**CITY OF EL PASO, TEXAS
AGENDA ITEM DEPARTMENT HEAD'S SUMMARY FORM**

Discussion and action on an appeal by applicant regarding a decision rendered by the Historic Landmark Commission (HLC) in HLC case PHAP14-00007 at 109 N. Oregon Street, El Paso, Texas, on May 5, 2014 to deny a certificate of appropriateness application for the referenced property (District 8).

SUBJECT: Appeal of Historic Landmark Commission decision regarding PHAP14-00007

PHAP14-00007

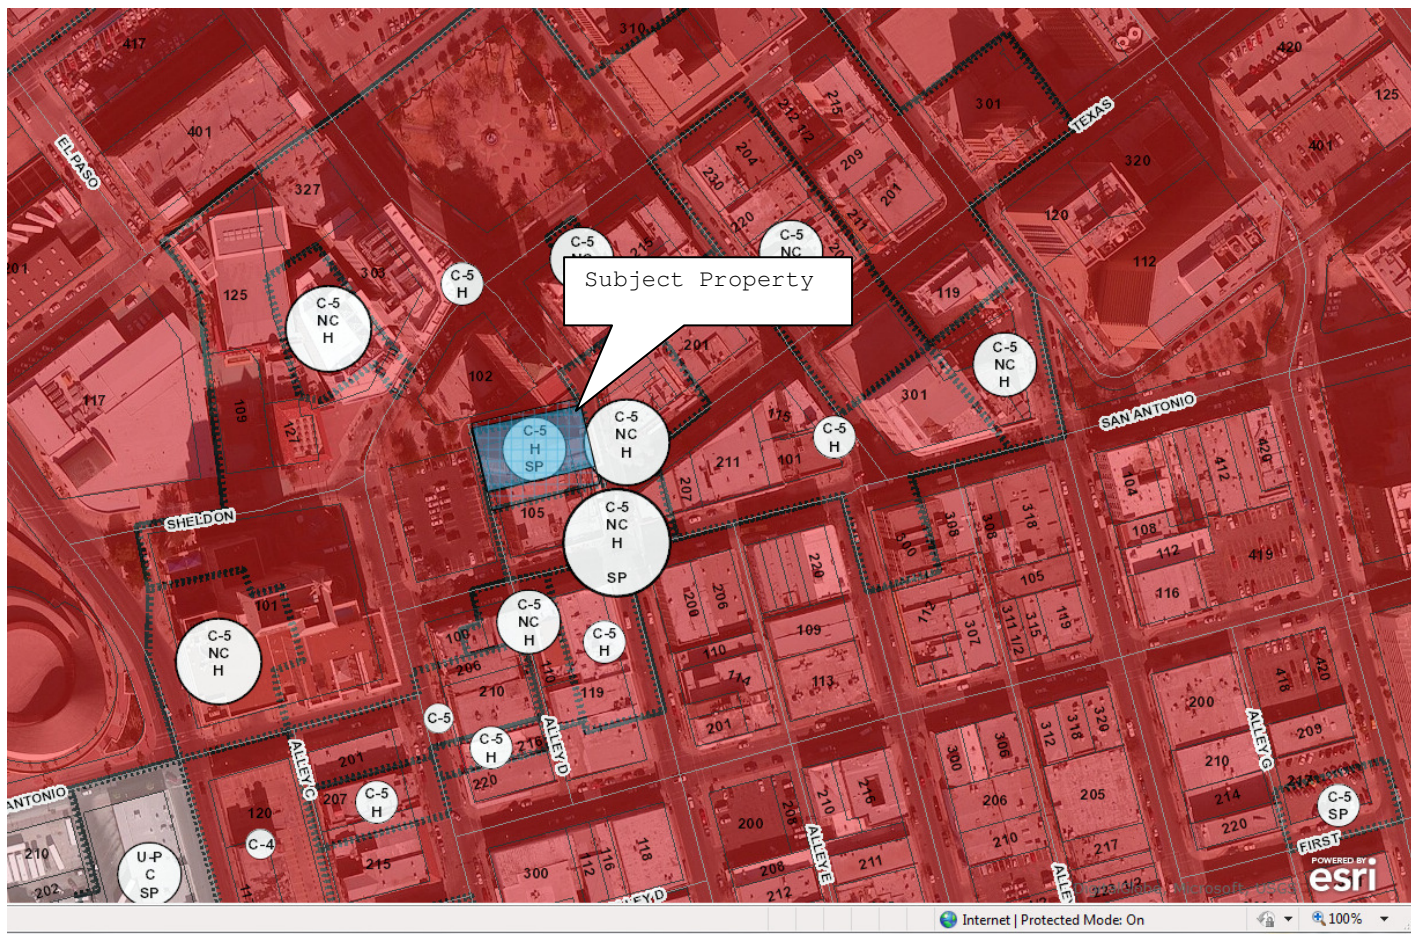
The Historic Preservation Office recommends DENIAL of the proposed scope of work based on the following recommendations:

The Downtown Historic District Design Guidelines recommend the following:

- Awnings and canopies should be placed at the top of openings, but they should not cover important architectural details/elements.
- Awnings and canopies should be of an appropriate size and scale in relation to the building's façade.
- Fixtures should not extend across the facades of several buildings. Instead, fixtures should fit within vertical elements such as columns.
- Awning should not cover more than one-third of the window opening. Un-proportioned awnings may appear awkward.
- Fixtures should always fit within their openings. Attempting to fit a square awning into a round opening (and vice-versa) should be avoided. Generally, the shape of an awning should respect the shape of the window.

AWNING

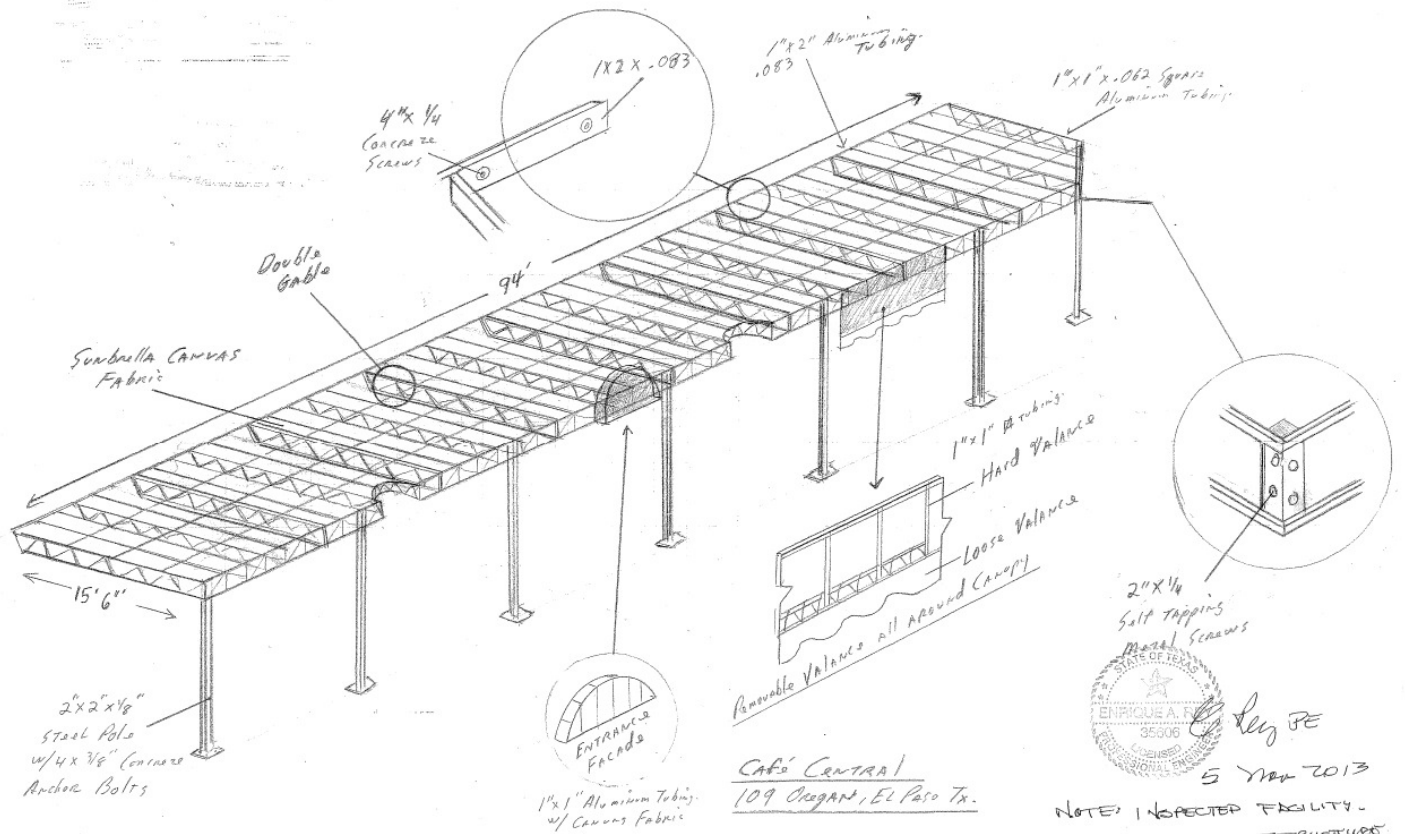
NOTE: INSPECTED FACILITY.
 IT IS A SOUND STRUCTURE
 (BLUM. TRUSS & METAL DECK
 STRUCTURAL STEEL COLUMNS)

Awning

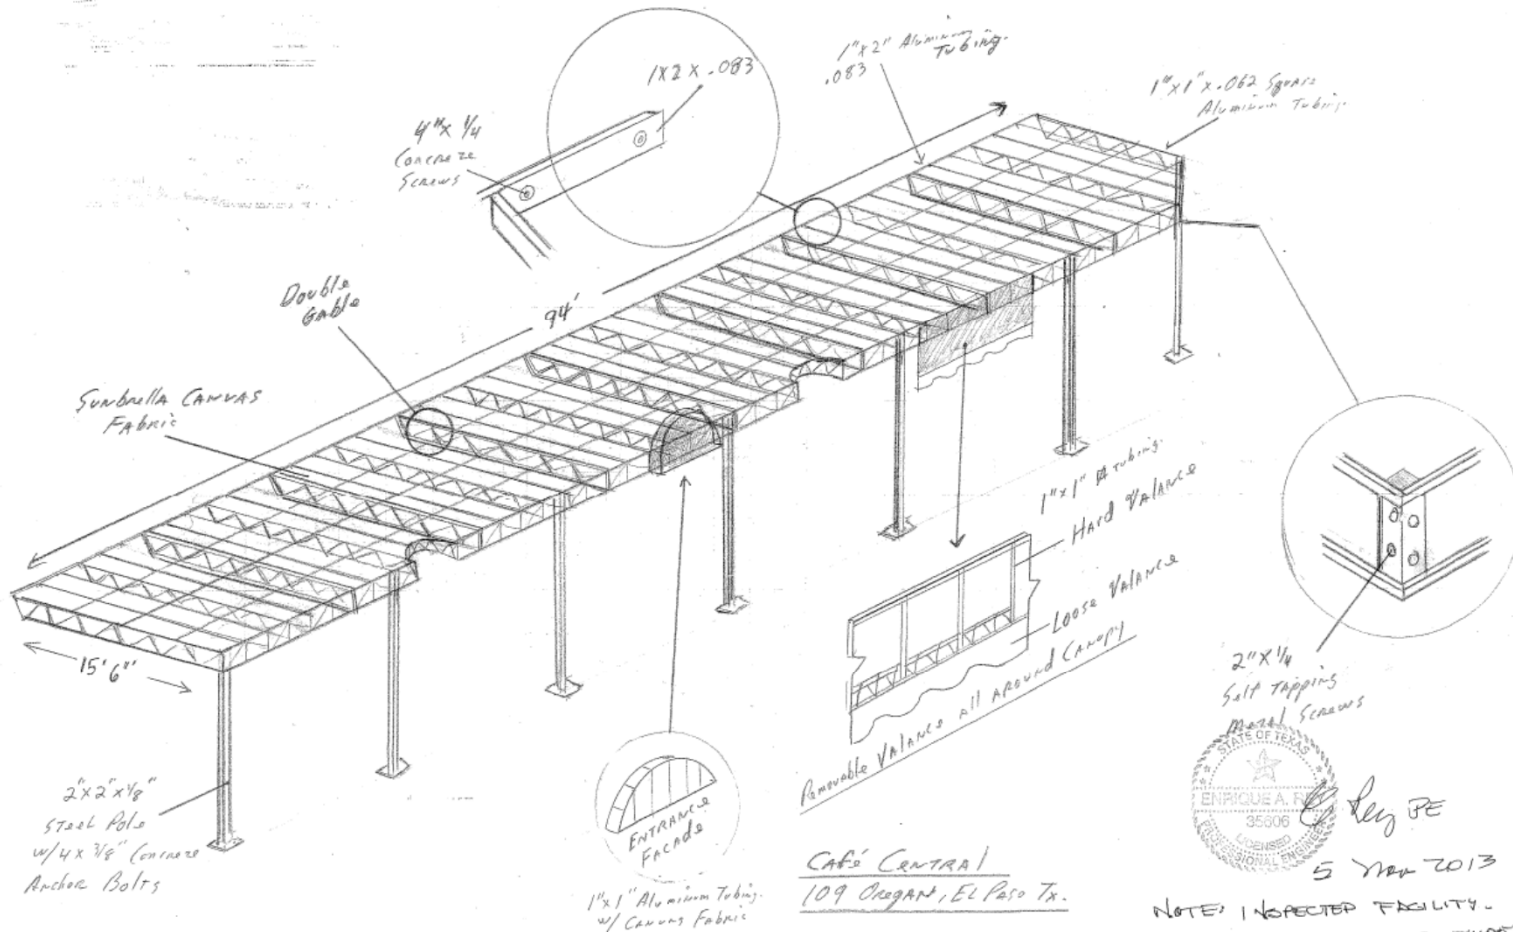
NOTE: INSPECTED FACILITY.
 IT IS A SOUND STRUCTURE
 (SLIM TRUSSES & METAL DECK
 STRUCTURAL STEEL COLUMNS)
